A TRANSNUCLEAR

July 2, 2004
ANUH-01-04-05

Subject: Response to the Request for Additional Information (RAI) for Chapter A.4 and Submittal of Revision 2 of Application for Amendment No.1 of Advanced NUHOMS[®] Certificate of Compliance (CoC) No. 1029 for Dry Spent Fuel Storage Casks (TAC No. L23606)

DOCKET NO. 72-1029
TAC NO. L23606

Figure A.4.7-8
Maximum Fuel Cladding Temperature during Vacuum Drying Using Air for Blowdown

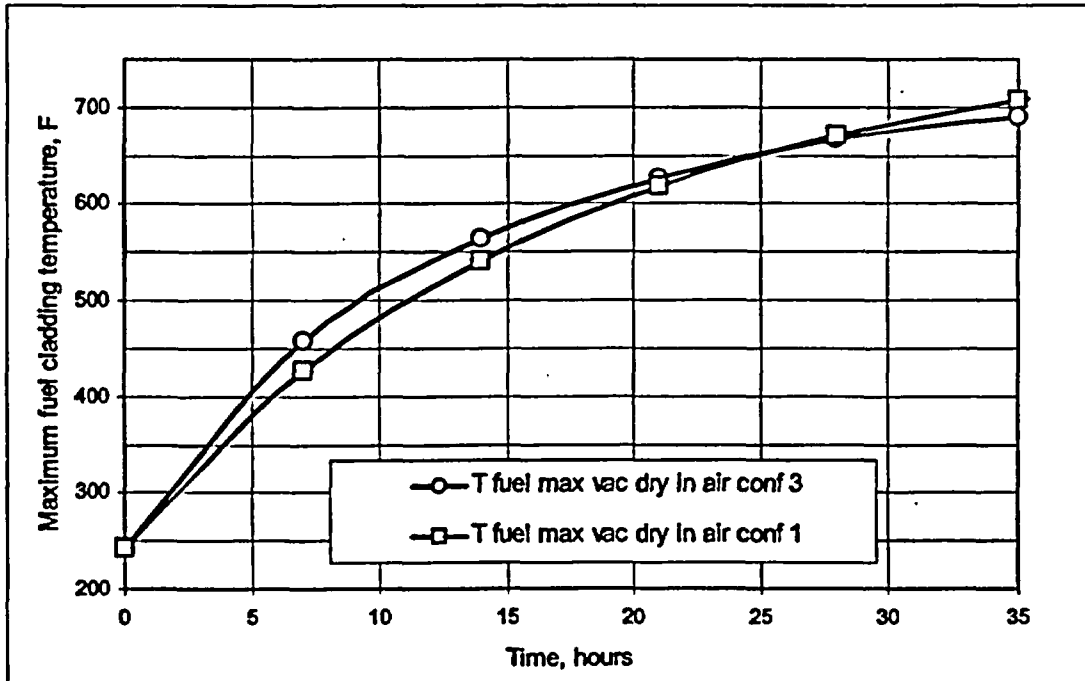
Question 4-7

Evaluate the initial conditions for the canister heatup analysis presented in SAR Section A.4.7.3 and revise them as necessary. Update all related analyses for air and helium as appropriate (accounting for new initial conditions and the issues presented in Question 4-1) and submit the model details and results for staff review. Provide a graph of maximum fuel cladding temperature versus time for helium (similar to Figure A.4.7-2 for air) in addition to an updated graph for air.

In order to assure that known conditions exist at the start of blowdown and also the initial fuel clad temperature assumed is conservative for the vacuum drying transient, the DSC cavity will be filled with water, if needed, to assure that the initial cladding temperature is bounded by the 230°F annulus temperature used in the vacuum drying transient. Section A.8 of the SAR is revised accordingly to include this step in the operating procedure.

Figure A.4.7-8 has been updated to reflect the conservative starting temperature of 230°F. The predicted helium steady state temperature demonstrates that no time limit is required for the helium blowdown configuration. This analysis has been generated using the DSC CFD analyses. The model details are included in SAR Section A.4.4.4.
